Drawing: Proposed Floor plan - Amendment

Proposed Ground floor

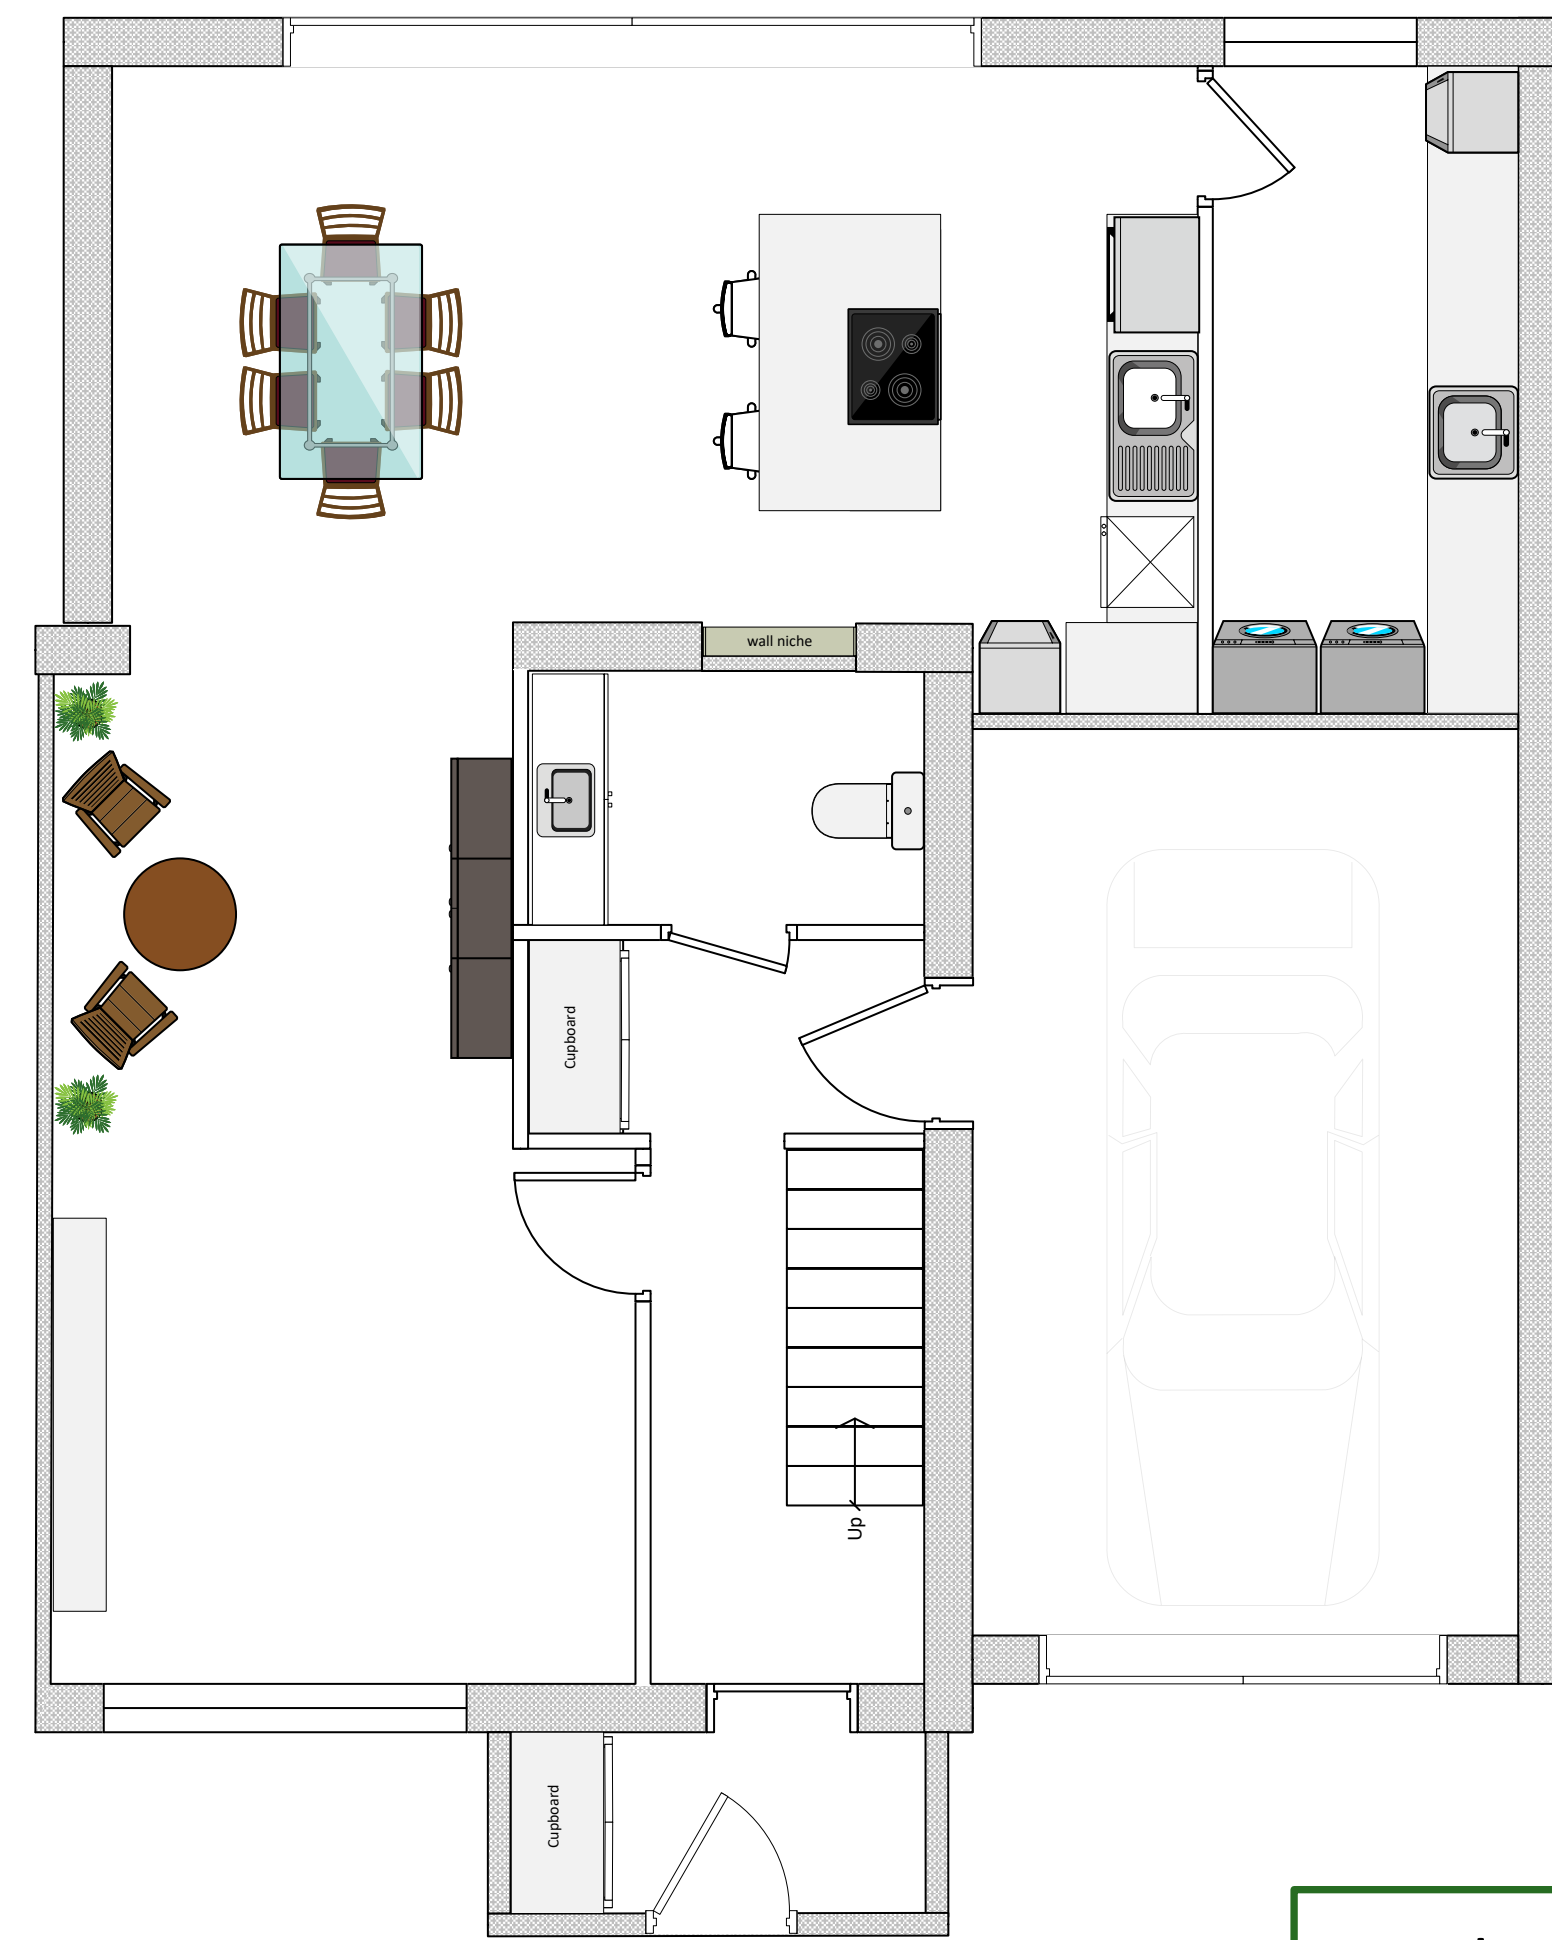
New brickwork on top of the existing dwarf brickwork – existing windows removed. Front door moved from the side (North elevation) to the front (east elevation). Foot print to stay the same as existing.
